## Item 3: Public Questions (Bow Farm)

***“10 questions for the Gloucestershire Planning Department and the Planning Committee regarding the sand and gravel extraction at Bow Farm under the Planning Application number 19/0081/TWMAJM.***

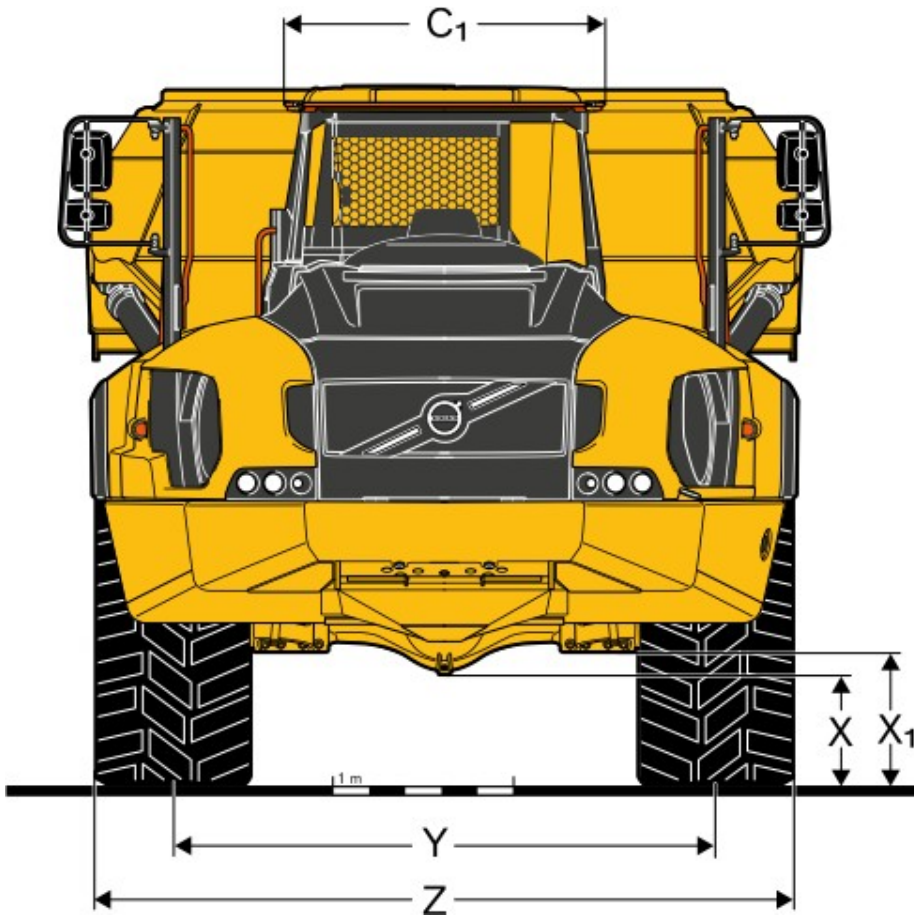
The rider shown below is 0.7m below the causeway used by the trucks - see below. Everything is as far as possible to scale.

The vehicle above is a typical large dumper truck used in a sand and gravel quarry. Because there are no details presented by the planners or the quarry applicant we have taken what would be required if the applicant's 50 dumper truck movements per day are correct. The vehicle is typically 3.8m high. Now we suspect the applicant has reduced the number of truck movements per day 'in error' and the reality is that there will be over 200 not 50. However the height of a typical truck for the reduced capacity would not be reduced that much - these are modular type vehicles, so it might be 3.4m not 3.8m high. Again in the absence of any meaningful information from the applicant or the planners we think the haul route will be raised some 0.6/0.7m above the level of the bridgeway as the area floods to a depth of at least 0.5m on a regular basis - it is on a flood plain. The horse and rider are scaled to approximately a 16 hands animal. You can see the problem. Note that the spacing between the truck and the rider is typical of what will occur on the bridgeway with a 1.6m post and rail fence - not shown. The vehicle shown does not have a flashing beacon light on the roof but most vehicles in use will have this feature.

**Officer response (11):** There would be no land raising to facilitate the proposed haul route.
